**Affected Products:** IPN-ProRemote  
Part numbers; IPNPRO, IPNPRO-S - Serial numbers; 1059500 or earlier

**Purpose:** Upgrade to Resolve Electrostatic Discharge (ESD) Induced Reset or Lockup

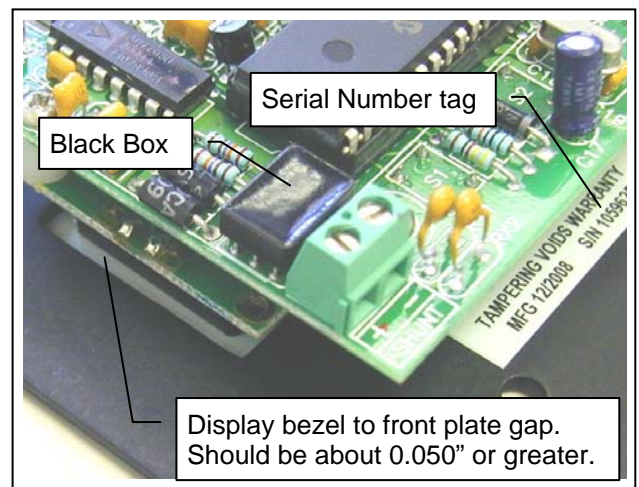
A small population IPN-ProRemote displays with serial number less than 1059500 may have a combination of aluminum display panel and LCD display device that can lead to lock-up or reset if a static spark jumps from the user's finger to the front panel. Should this occur the unit will operate normally following the reset but present battery amp-hour and percent capacity information will be lost until the charge controller again enters Float. The potential problem tends to be worse in conditions of very low humidity due to increased static electricity.

An upgrade is available to those customers experiencing this problem at no cost during the warranty period. The upgrade can be performed at Blue Sky Energy through the normal warranty process or is available as an upgrade kit, BSE part number 930-0042. Cost for the upgrade kit for units not under warranty is \$29 plus shipping. The kit consists of a new front panel with overlay and a different micro-processor with greater ESD immunity.

Circuit board attachment screws

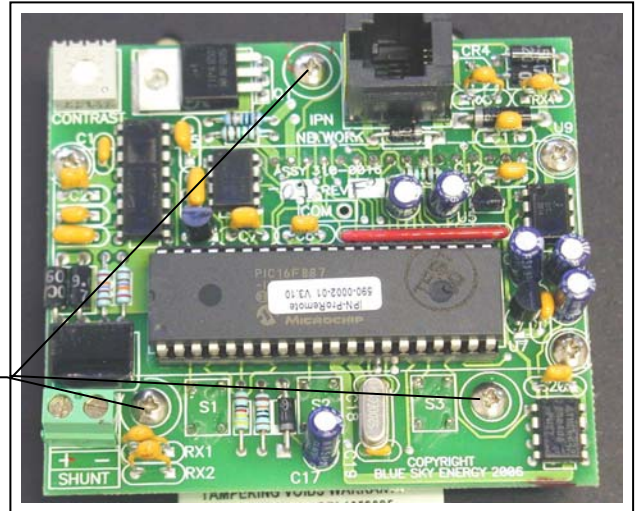
1. For continued warranty coverage copy serial number and mfg date from the old front panel to the new front panel serial number tag. Destroy and discard the old panel.
2. Remove three screws attaching the circuit board to the old front panel. Take care to not damage the long button actuators and install the circuit board onto the new panel.

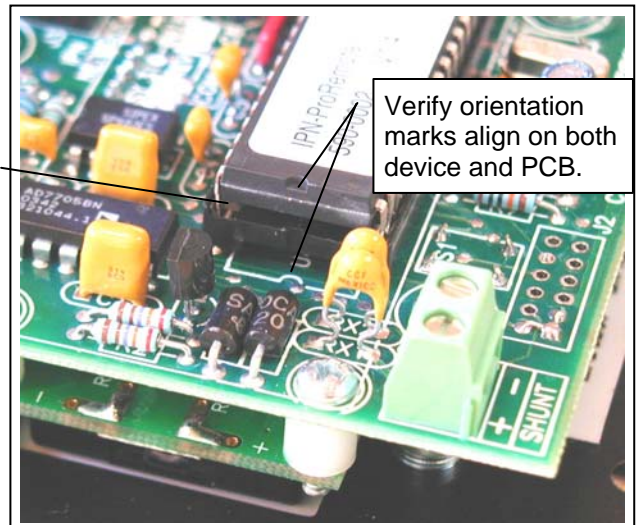
1. Units with microprocessor version V3.10 or later do not require microprocessor replacement.
2. With a small screwdriver or similar tool, carefully pry the existing microprocessor out of it's socket. Rocking the device end-to-end slightly will help.
3. Place new device lightly into socket without pressing into place. **VERIFY** CORRECT DEVICE ORIENTATION AND THAT ALL DEVICE PINS ARE PROPERLY PLACED IN SOCKET BEFORE PRESSING DEVICE INTO PLACE.
4. Carefully press device into socket with two fingers or thumbs, one on each end of device. Visually inspect device pins to confirm all pins are properly seated into socket.

Verify placement of ALL pins in socket before pressing microprocessor into place.

Verify orientation marks align on both device and PCB.
